RE: Useable Area Report - Wyatt Subdivision

Attached is the Request for Comments (RFC) for Wyatt Estates, MSB Case #2016-164, Tech AOB. Also attached is the Vicinity Map, Owners' Statements, Soils Report and preliminary plat. Comments are due by DECEMBER 7, 2016. Please let me know if you have any questions. Thanks. A.

Subject: Abbreviated Plat Request for Comments – **Wyatt Estates (Case No. 2016-164)**

Enclosed is a drawing showing the approximate location of the service line and the requested easement.

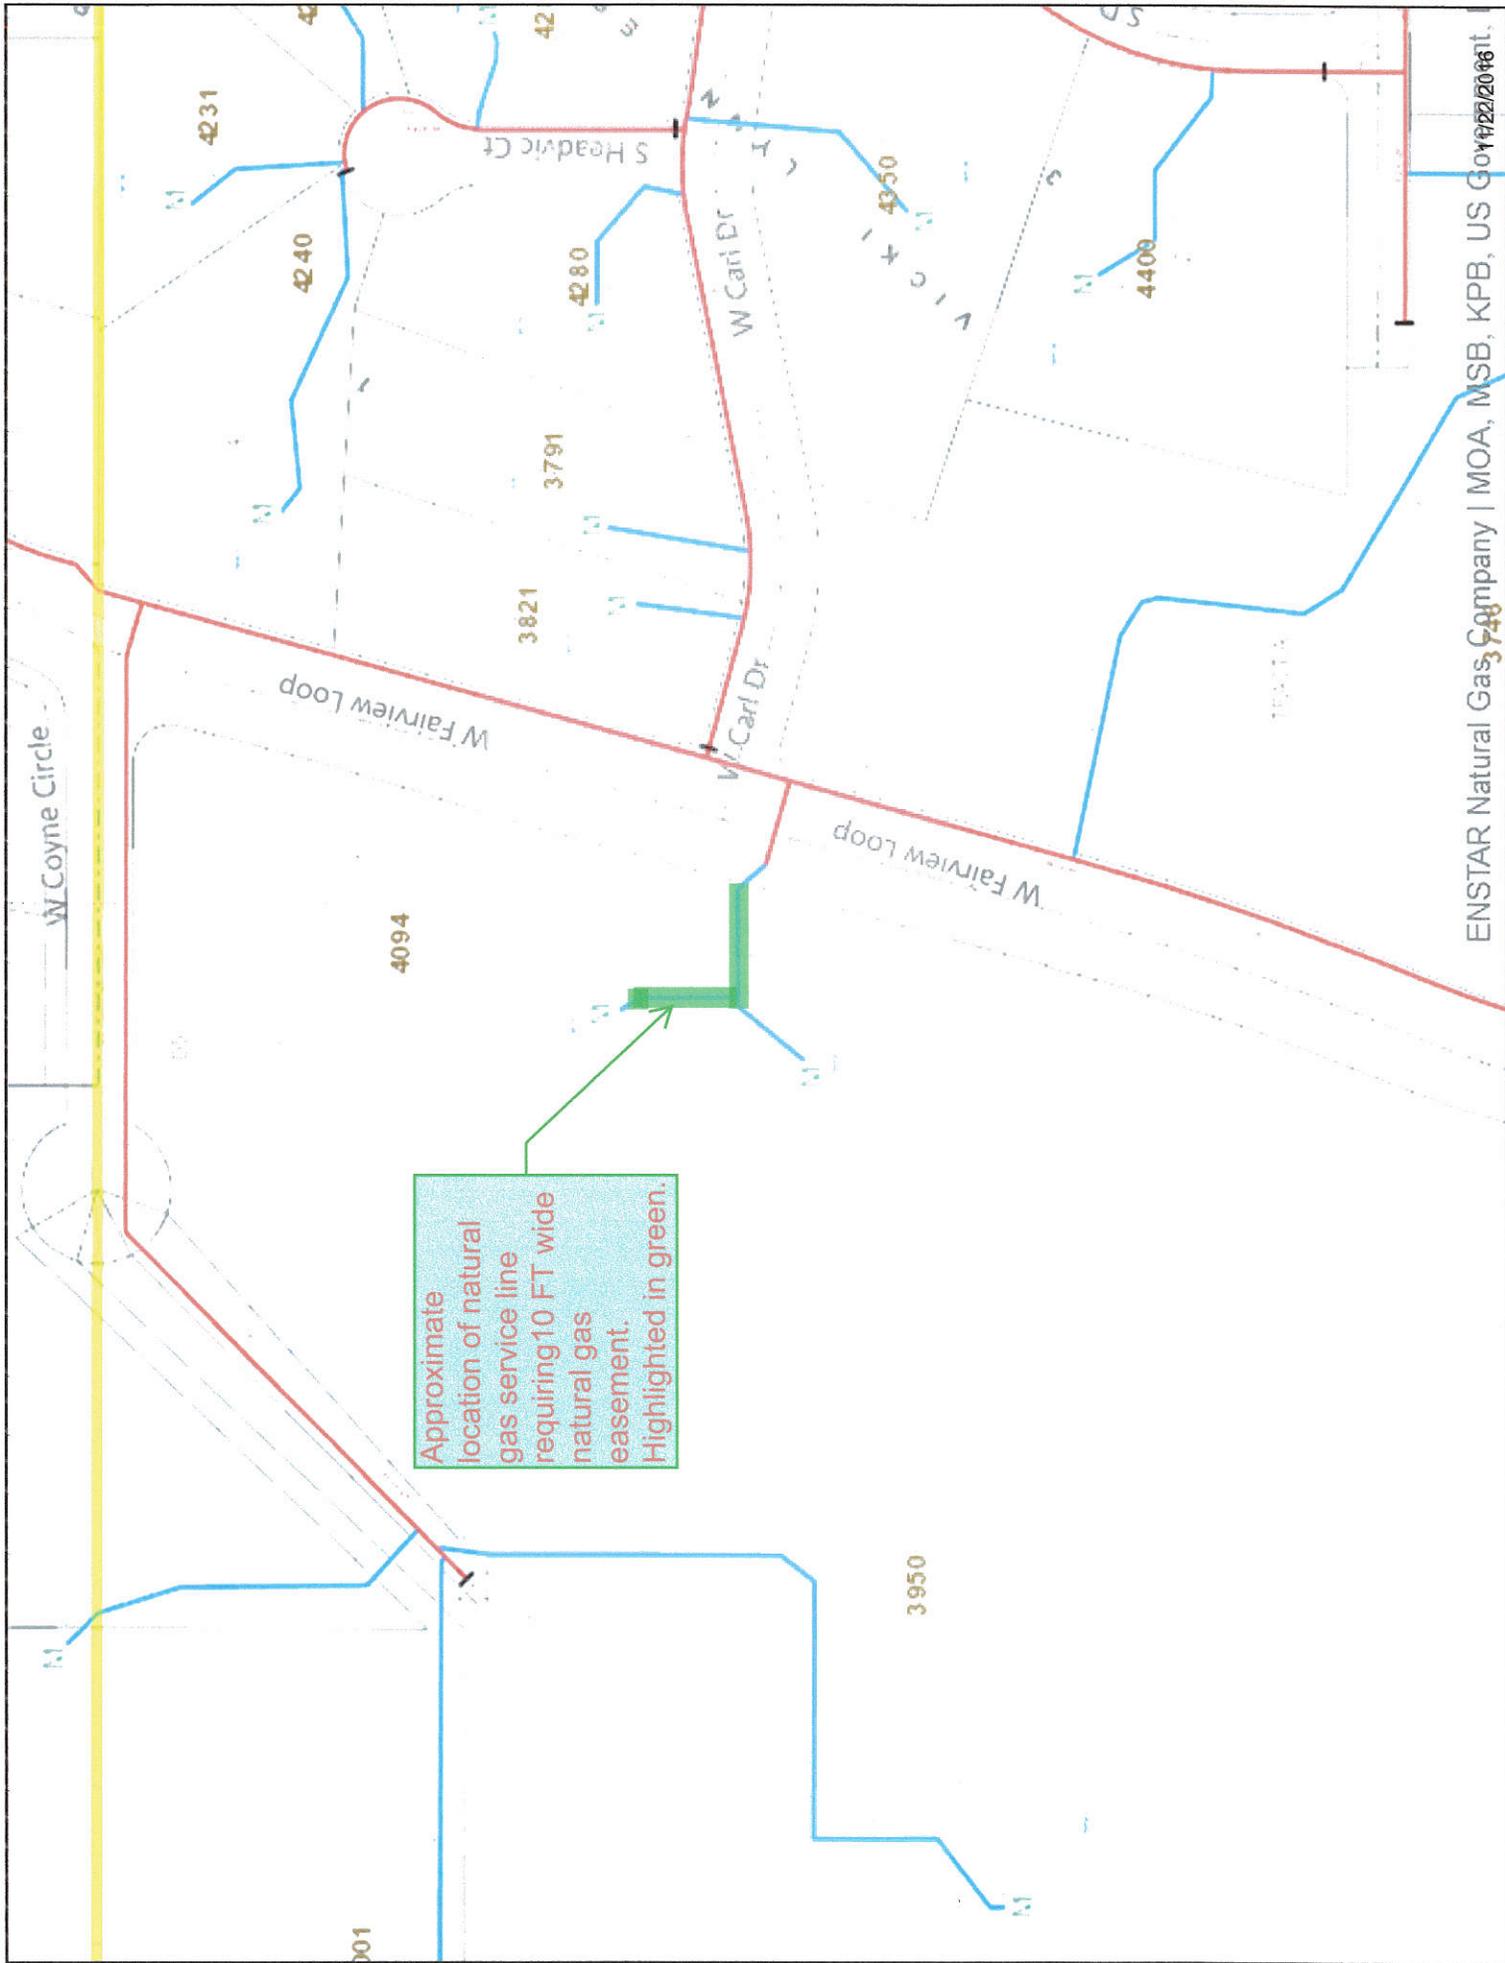
ENSTAR Natural Gas Company has reviewed the subject Abbreviated Plat and advises that a natural gas service line appears to cross proposed Lot 1, to provide service to the structure on proposed Lot 2. ENSTAR requests a ten-foot (10 FT) wide natural gas easement centered on the service line where it crosses the proposed Lot 1.

Utilities: (**Exhibit E**) MTA has no objections. Enstar advises there is a natural gas service line that crosses proposed Lot 1 that provides service to the structure on proposed Lot 2. Enstar is requesting a 10' wide natural gas easement centered on the service line where it crosses proposed Lot 1. *Staff notes abbreviated plats cannot grant easements; if petitioner wishes to grant this easement, they may do so by document, record the easement and show the location and recording information on final plat.* GCI approved as shown. MEA did not respond.
